Administrative Approval Action

Case File / Name: SR-51-18 Conn Elementary
Transaction # 557021, AA # 3906

REQUEST: Recombination and redevelopment of a 16.37-acre site zoned R-10 into a 113,390 square foot civic building for a new public elementary school.

Design Adjustment Staff Response

Block Perimeter Requirement: 2,500 LF, shown: 5,442 LF @ 200 scale

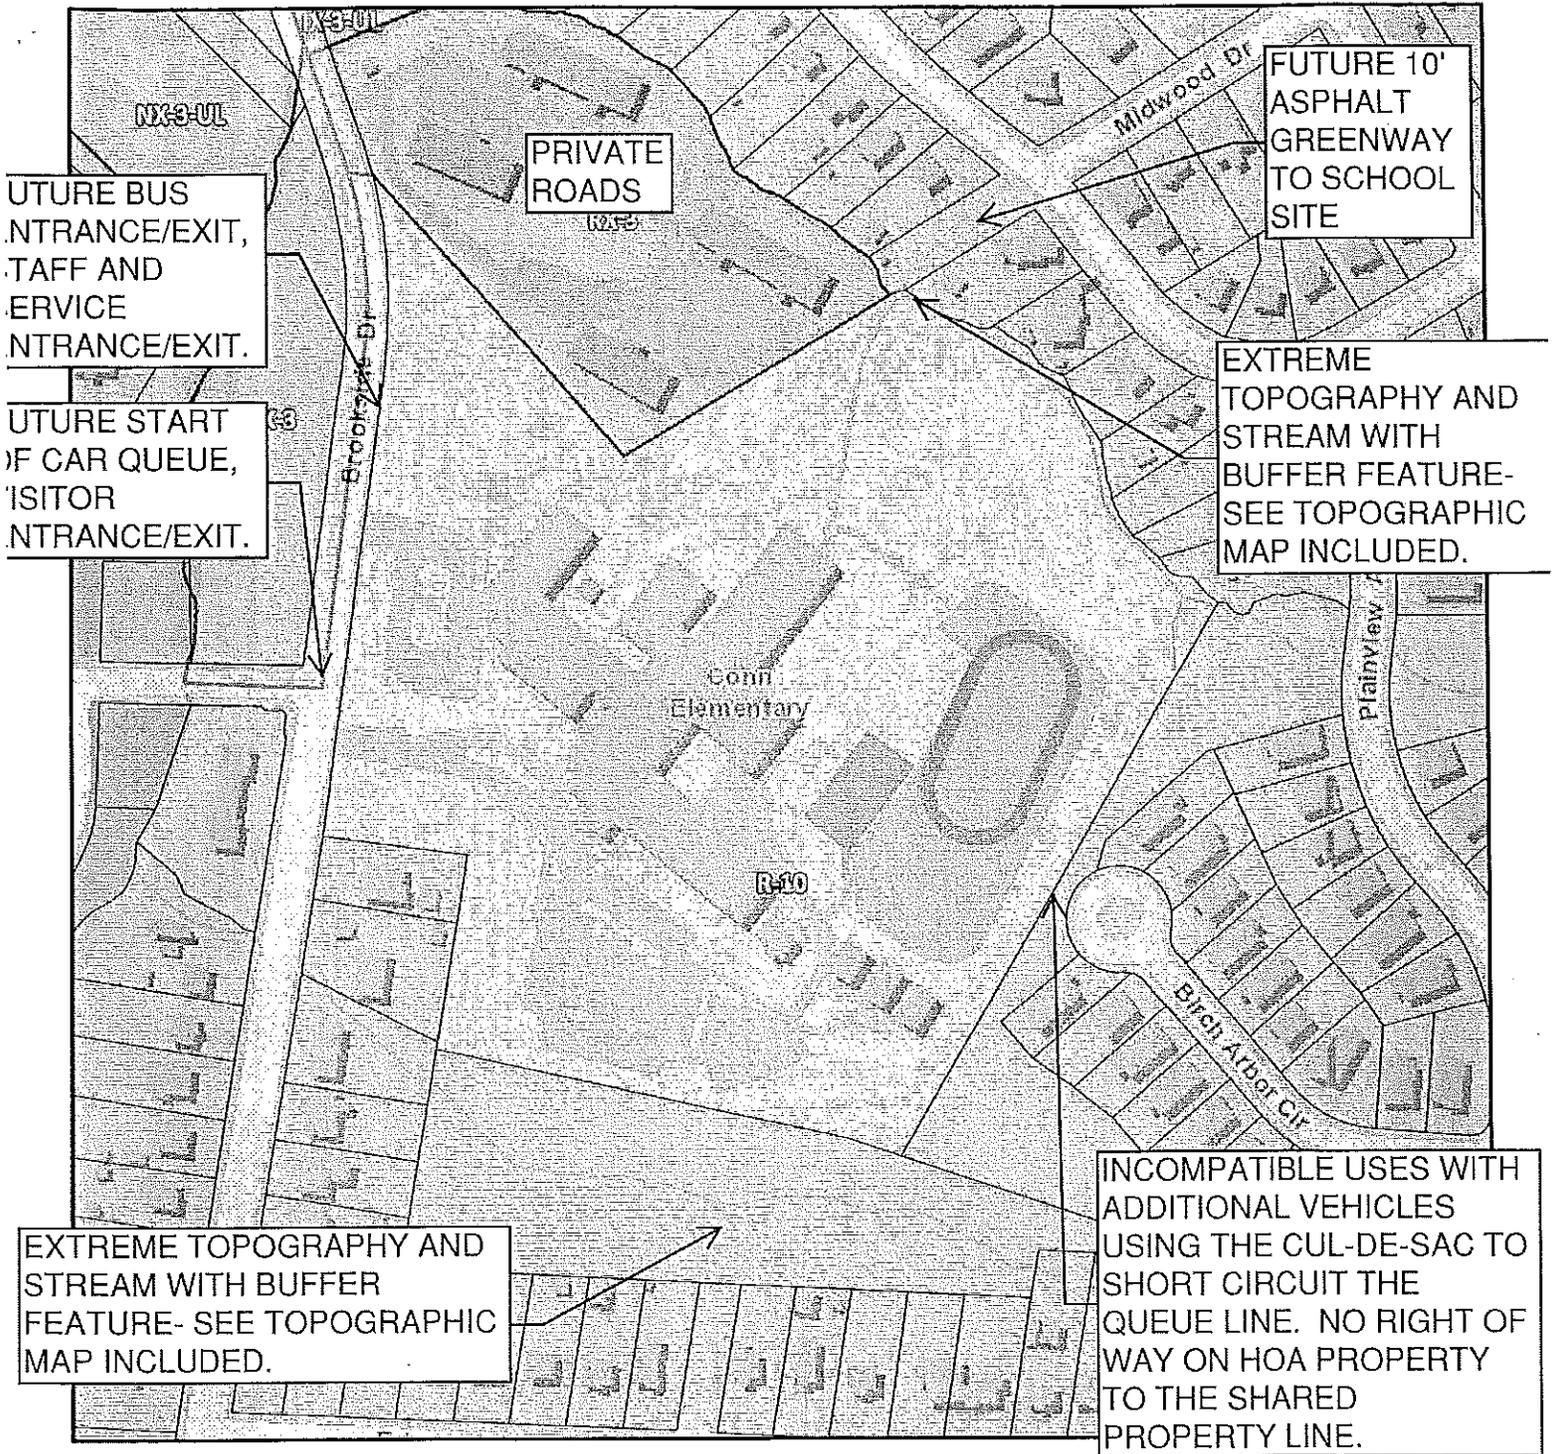
Per the City of Raleigh UDO, the maximum perimeter for this site zoned R-10 is 2,500 LF. Using Wake County IMAPS, the block perimeter (magenta line) as shown in the attached image is 5,442 LF as measured at the right of way per code section 8.3.2.B. The block perimeter requirement is not met with existing conditions.

E1. There is severe grade change (15-20') along the southern border as well as severe grade change along the Northern border. See attached GIS topography map.

E2. There are existing streams and buffers along the northern and southern borders. See attached photographs and GIS topography map.

Meeting block perimeter requirements through a new public street connection is inhibited due to steep topographic changes, site layout of developed properties, the presence of existing buildings and streams.

The plans proposed a pedestrian path 10' in width on a 20' easement improving pedestrian mobility in accordance with section 3.2.6 B of The Raleigh Street Design Manual. The pedestrian passage has also extended the block by 50% in accordance with Article 8.3 (B) (3) of The Raleigh Unified Development Ordinance. The allowable block is 3750'; the actual is 5,442.

Zoning Map and Incompatible Uses

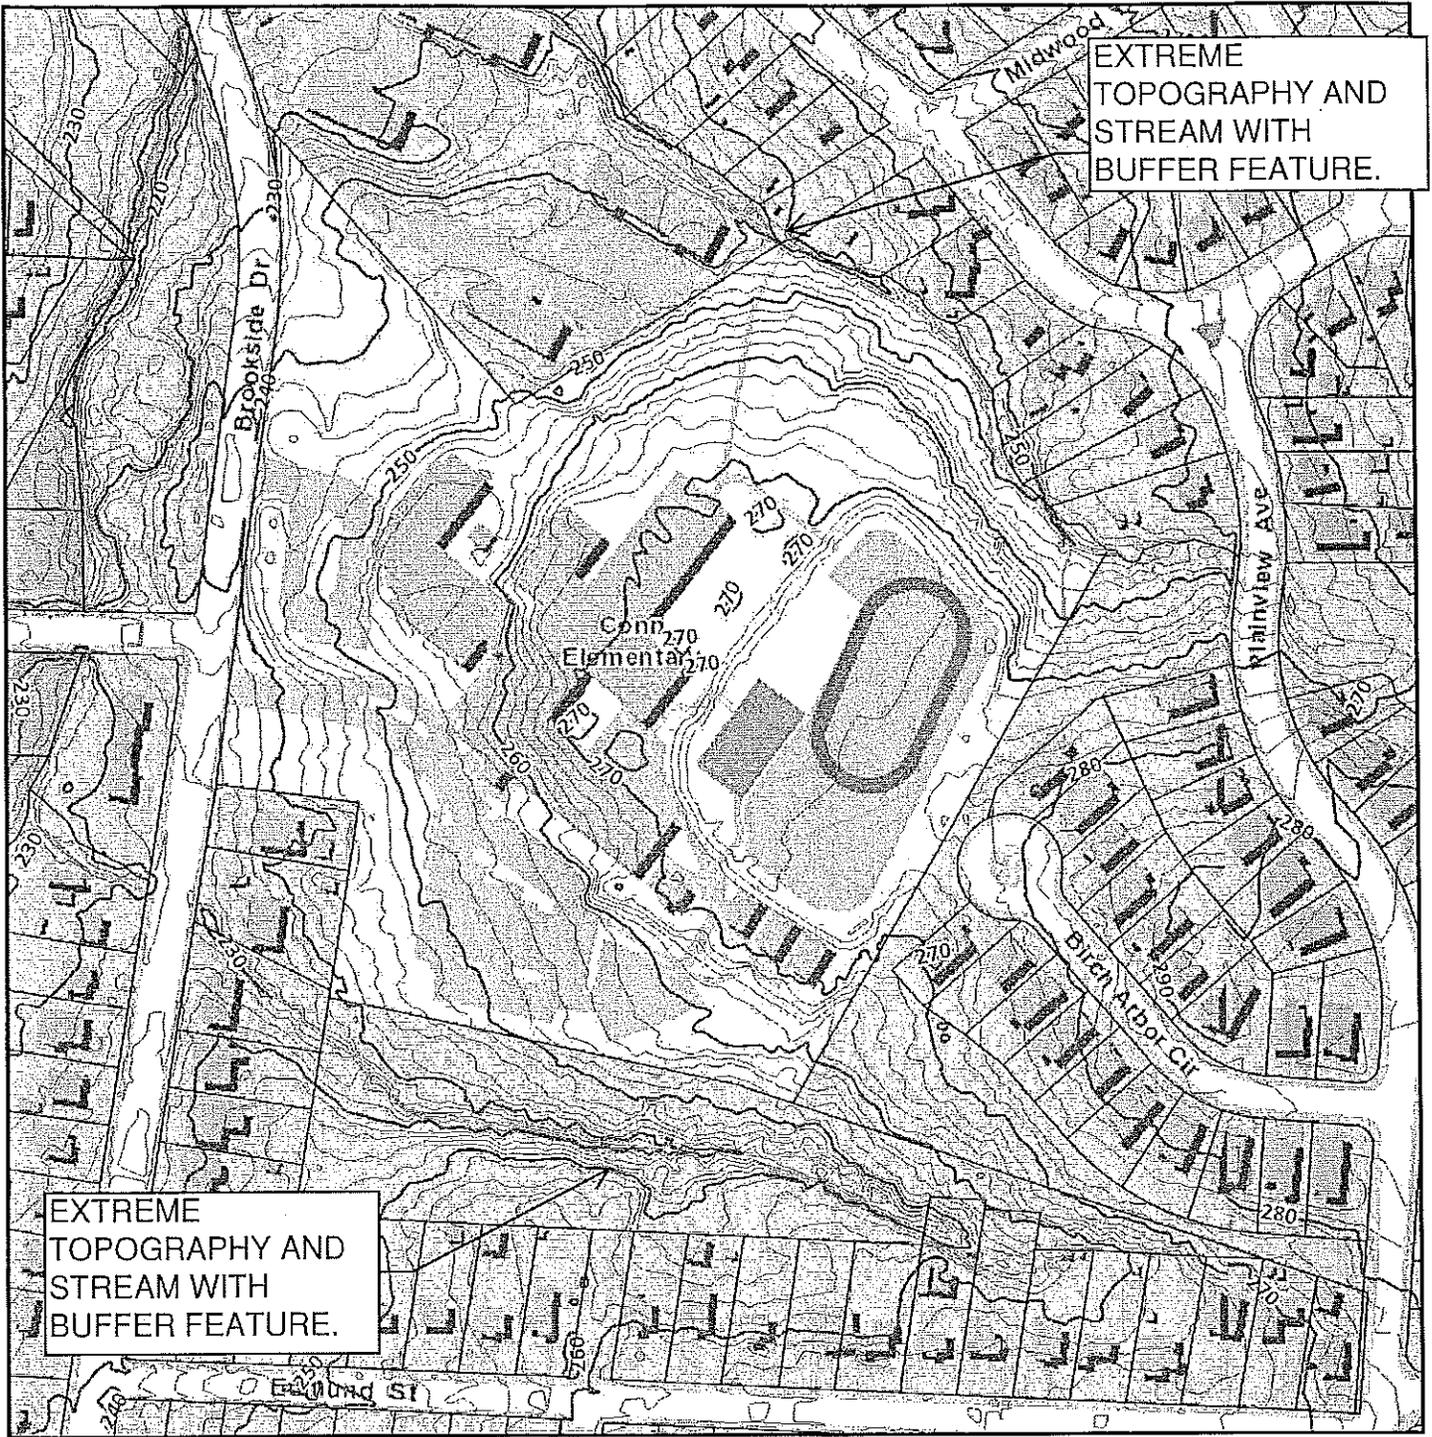
E4. The adjacent property to the east is residential. While compatible with a school for pedestrian connectivity (which is provided to the property line on Board property), vehicular connections at the end of a cul-de-sac, through an existing neighborhood, may be problematic to existing home owners. In addition, no right of way is provided to the Board owned property from the cul-de-sac. Lastly, the newly designed school site meets all site requirements by NCDOT MST A, NCDPI, NCDOI, City of Raleigh UDO and WCPSS design guidelines and the topography challenges with the newly designed site does not lend itself to providing a road in this location.
